**From:** [William Hodgkinson](#)  
**To:** [Andrew Cowan](#)  
**Cc:** [Sheelagh Laguna](#); [Bianca Thornton](#); [Travis Lythall](#); [Stephen O'Connor](#); [Paul Solomon](#)  
**Subject:** SSD 9667 Kemps Creek Warehouse, Logistics and Industrial Facilities Hub  
**Date:** Friday, 23 August 2019 4:15:00 PM  
**Attachments:** [Peer Review.pdf](#)

# **Mamre South Precinct Peer Review of the Overland Flow Report Stage 1 (Rev A)**

**Project: Mamre South Precinct, Mamre Road, Kemps Creek**  
**Peer Review of the Overland Flow Report Stage 1 (Rev A)**

**Figure 1 Comparison of RMA model 1% AEP flows with TUFLOW model inflows**

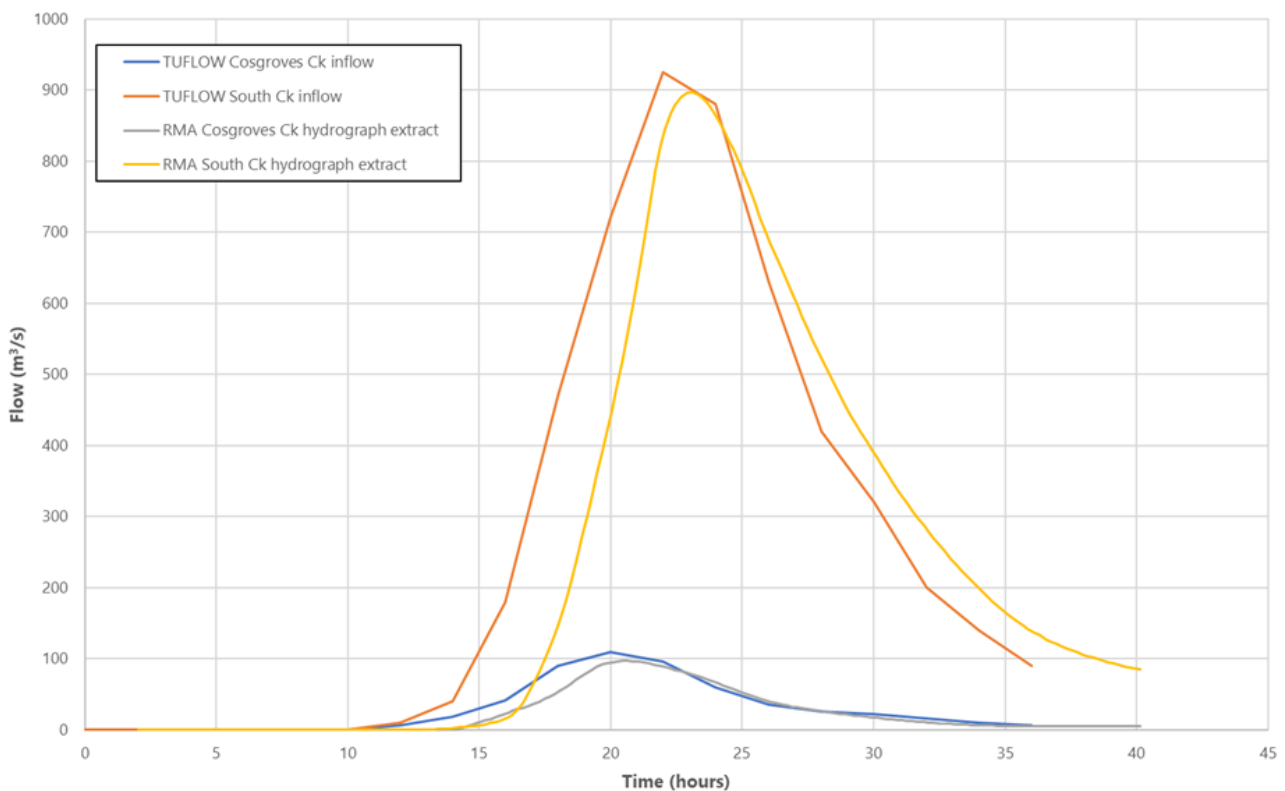
- Comparison of TUFLOW inflows to RMA-2 model flow hydrographs extracted at relevant locations using waterRIDE™ (refer **Figure 1**). Observations made from that comparison are as follows.

- Hydrograph shapes, peak flows and total volume are similar
  - A slight offset in the start of the flood hydrographs is evident
  - The TUFLOW inflow hydrograph shapes are somewhat simplified (i.e. due to the 2 hour timestep used to define them) and have slightly higher peak flows than those extracted from the RMA model using waterRIDE

- Overall it appears that appropriate data has been adopted to define inflows to the truncated TUFLOW model
- Comparison of peak 1% AEP flood levels simulated using the TUFLOW and RMA-2 models (refer **Figure 2**). Observations made from that comparison are as follows.

**Figure 2 Difference in simulated 1% AEP peak flood levels (TUFLOW minus RMA)**

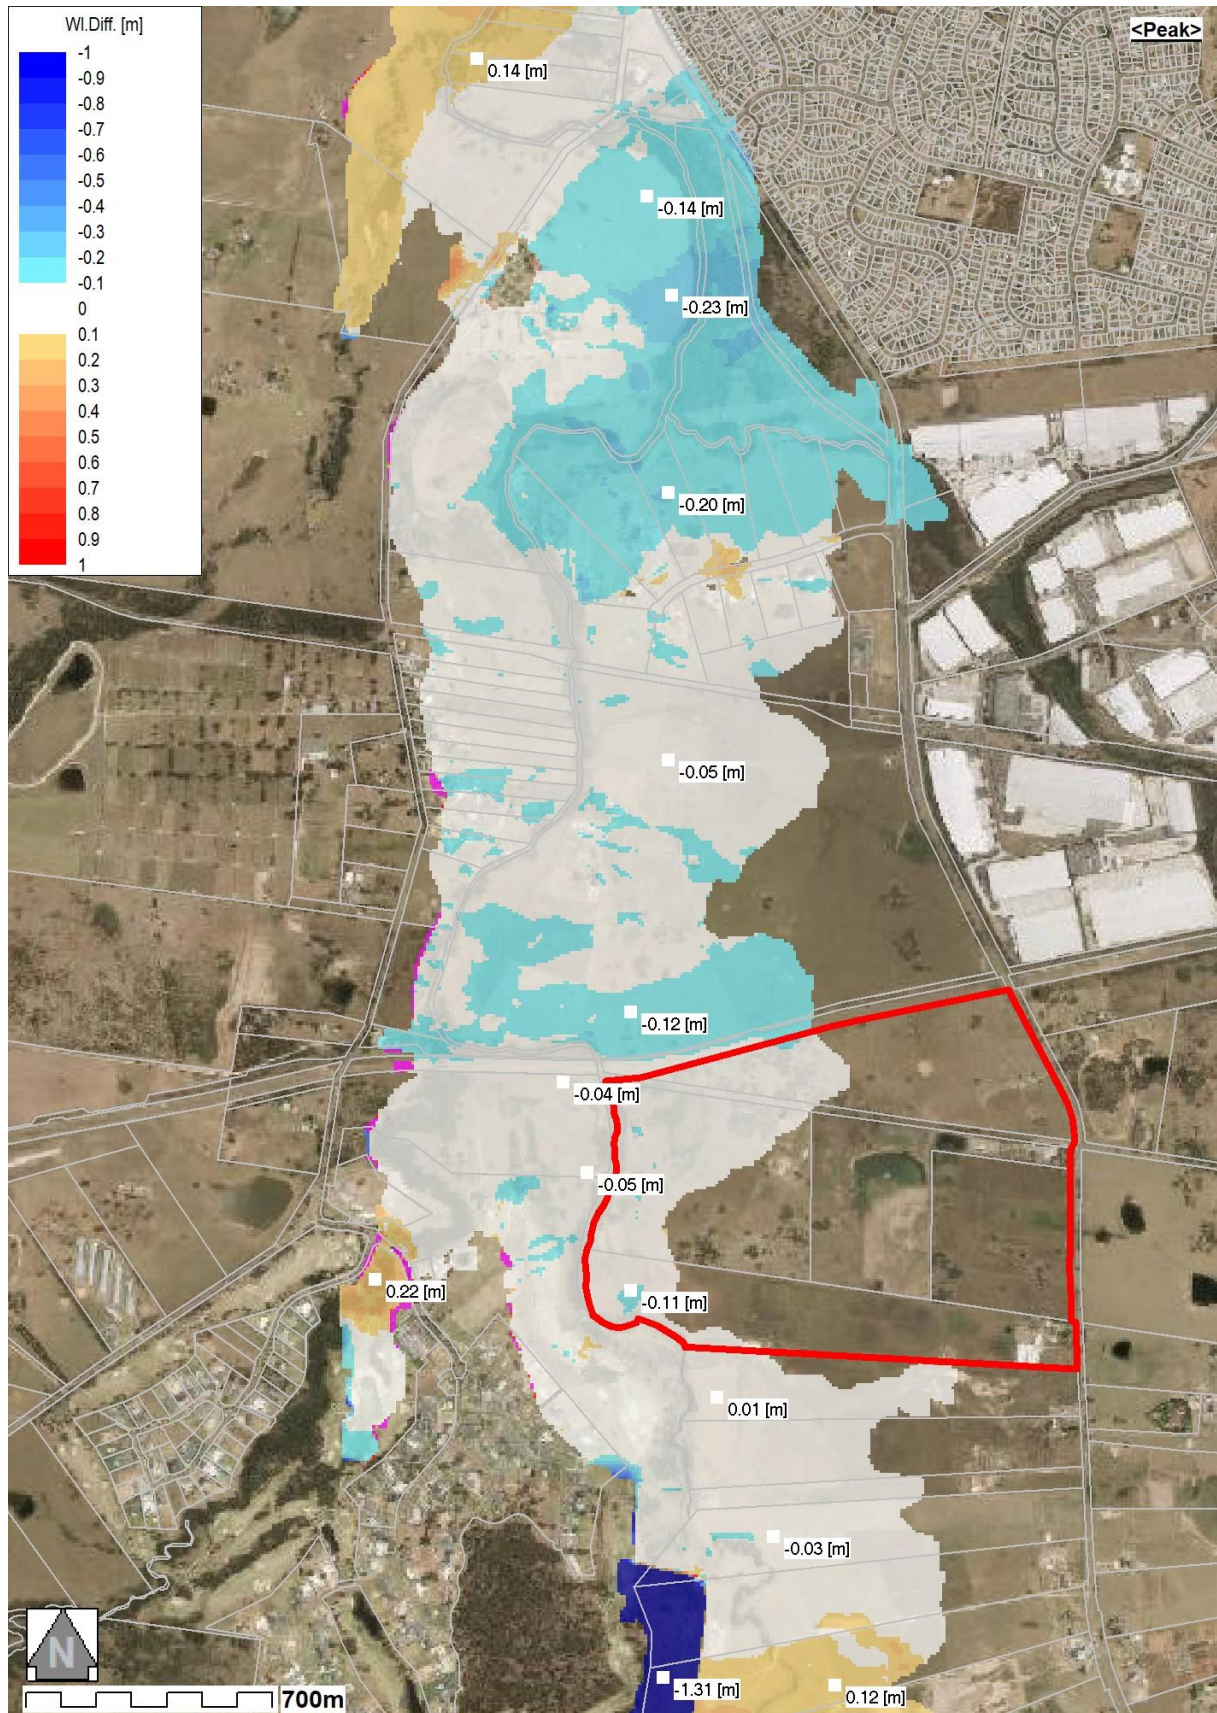
- In the immediate vicinity of the proposed development site pre-development TUFLOW peak flood levels range from about 10 mm higher to 120 mm lower than the peak flood levels generated by the RMA-2 model, but are typically about 50 mm lower.

- Some larger differences are observed further afield from the site including:
    - TUFLOW levels about 120 mm higher near the South Creek inflow boundary

- TUFLOW levels about 1.3 m lower within the South Creek Dam
  - TUFLOW levels about 200 mm lower north of Mandalong Close
  - TUFLOW levels about 140 mm higher north of Luddenhum Road

- TUFLOW levels about 220 mm higher on Cosgroves Creek upstream of Twin Creeks Drive
- While differences in 1% AEP peak flood levels simulated by the RMA model and truncated TUFLOW model are evident, this is not unexpected given the change in modelling software, associated differences in model setup and numerical solvers, the change in model extent and boundary conditions, and the adoption of more recently acquired LiDAR data defining the floodplain topography.

- The South Creek inflow boundary should arguably be moved further upstream to ensure flow behaviour is properly resolved in the vicinity of the South Creek Dam and Kemps Creek confluence, however relatively low differences in flood level upstream of the site indicate that this may not be necessary (**Finding A1**).

**Figure 3 Comparison of pre-development and post-development TUFLOW material delineation**

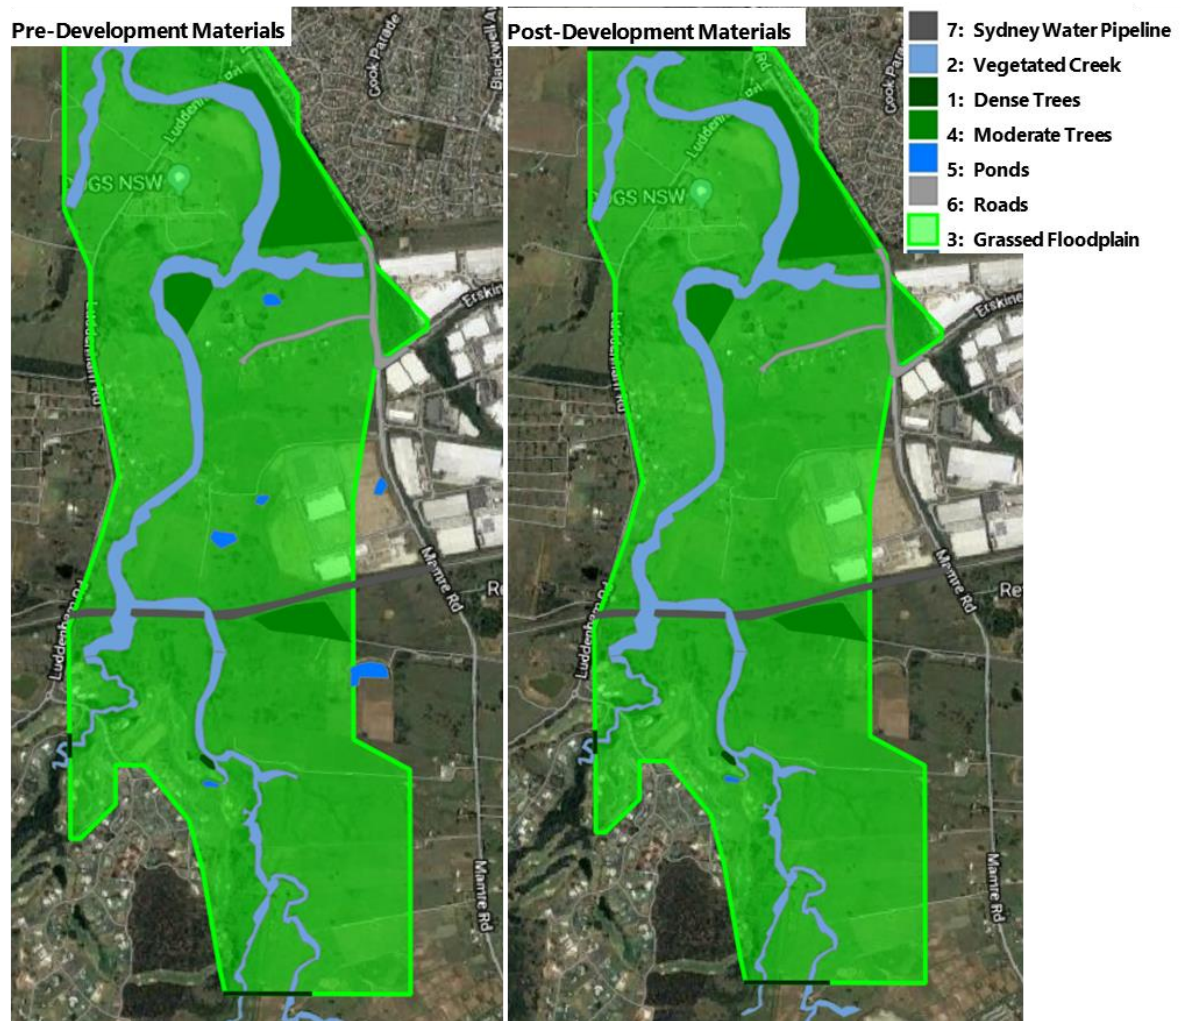
- Differences between pre-development and post-development scenarios
    - Several "Ponds" are present in pre-development conditions but not post-development

- The post-development scenario has not accounted for changes in landuse and Manning's 'n' associated with new and proposed commercial/industrial development. While the post-development terrain is predominantly above the 1% AEP peak flood level, the changes in land use may affect larger floods such as the 0.5% AEP and PMF (**Finding A2**).

**Figure 4 Comparison of pre-development and post-development TUFLOW model terrain**

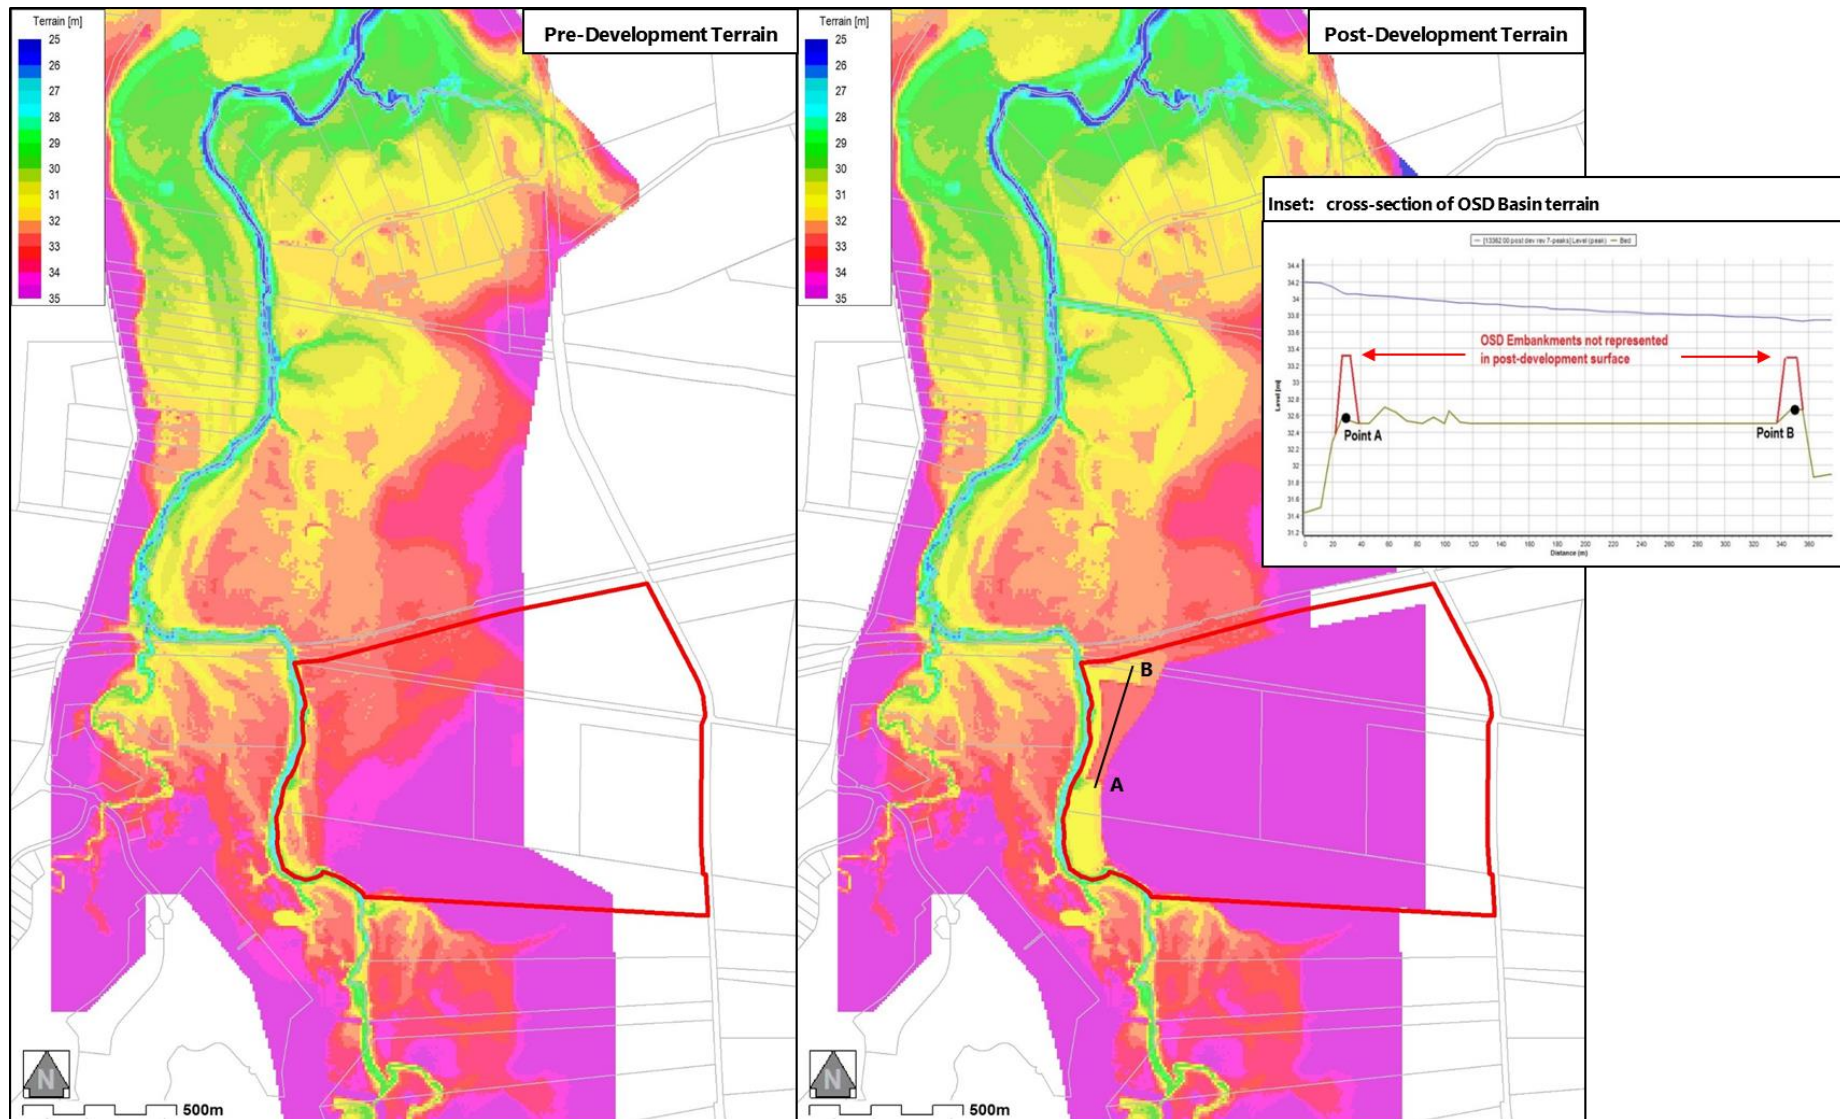
- Review of basin embankment crest elevation
    - + A definitive RL for the crest of the basin embankment could not be confirmed from review of the Overland Flow Report, Water Cycle Management Strategy or associated drawings.

- + Based on model terrain elevations it appears that the TUFLOW modelling intended to adopt a crest RL of 33.3 mAHD, just 0.3 m higher than the proposed overflow weir RL of 33.0 mAHD and 0.2 m higher than the maximum detention level quoted on drawings.

- + Review of the post-development TUFLOW model terrain using waterRIDE indicates that the crest RL ranges from 32.5 to 33.3 mAHD, with RLs of less than 33 mAHD along much of its length (>50%). Such a topographic representation would result in the obstruction to flood flows caused by the basin being under-represented (**Finding A5**). A profile across the OSD basin in the direction of flow is shown in **Figure 4**.

- + It is noted that the TUFLOW terrain reviewed comprises of a raster created by triangulation of the actual terrain elevations (at grid cell centre, corner and mid-side nodes) used in hydraulic calculations. Thin 'breakline' features in the model terrain used to set elevations along only the sides of model grid cells can be excluded or smoothed out from this raster interpretation of the TUFLOW terrain. However, without any indication within the Overland Flow Report or the provided TUFLOW files that 'breaklines' have been used, it appears that the modelling does not adequately define the basin and the obstruction it could cause to floodwaters.

**Figure 5 Difference in TUFLOW model terrain (post-development minus pre-development)**

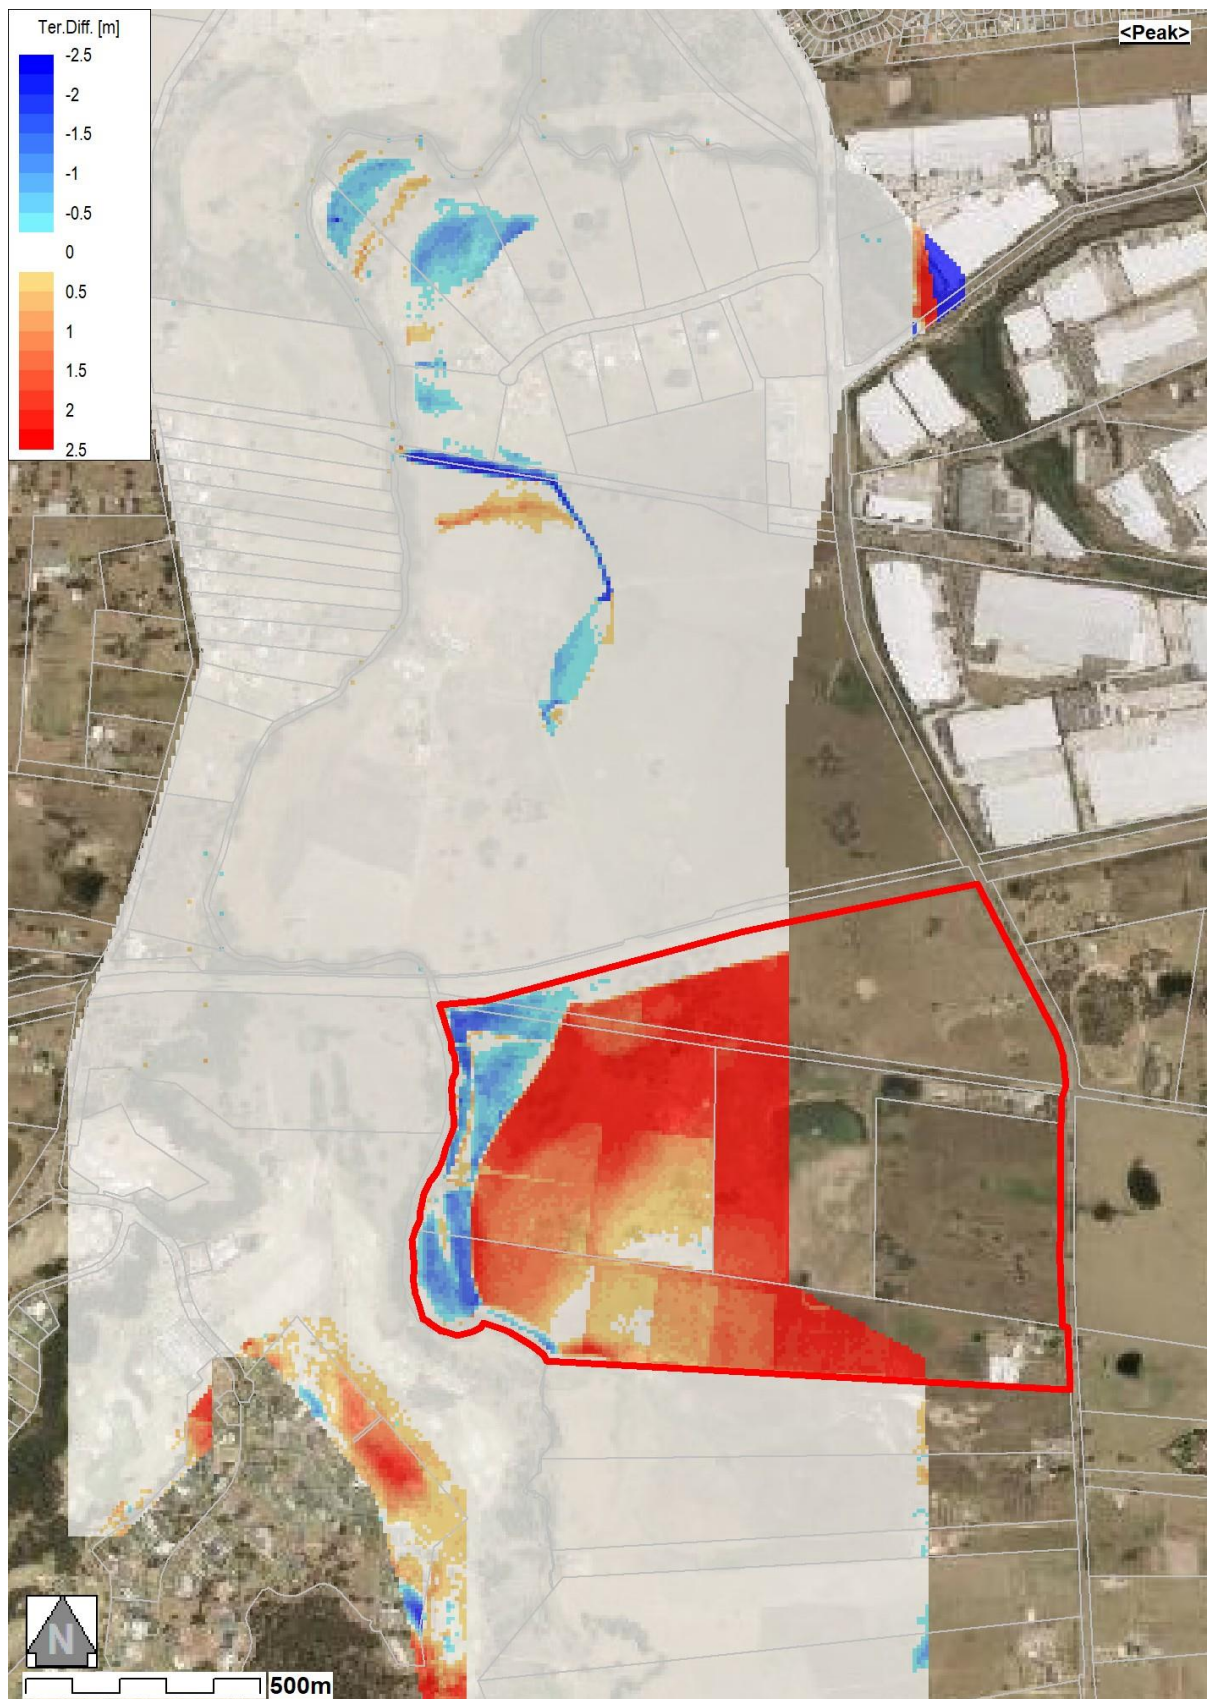
- Terrain changes incorporated in the post-development model (refer **Figure 5**) include:
  - Medinah Avenue, Twin Creeks development (constructed):
    - + Generally, increases in ground level of up to about 2.5 m

- First Estate Stage 1 (constructed):
    - + Generally, decreases in ground level associated with drainage
  - First Estate Stage 2 (proposed):
    - + Both increases and decreases in ground level associated with regrading, differences are up to about 1.0 m

- Mamre South Precinct (proposed):
    - + Increases in ground level across most of the site associated with filling, differences are generally 1.0 m or more and are up to about 5.0 m

- + Decreases in ground level along the western edge of the site associated with cut, re-grading and the on-site detention basin. Differences are generally in the order of 1.0 m or more are up to about 1.8 m.
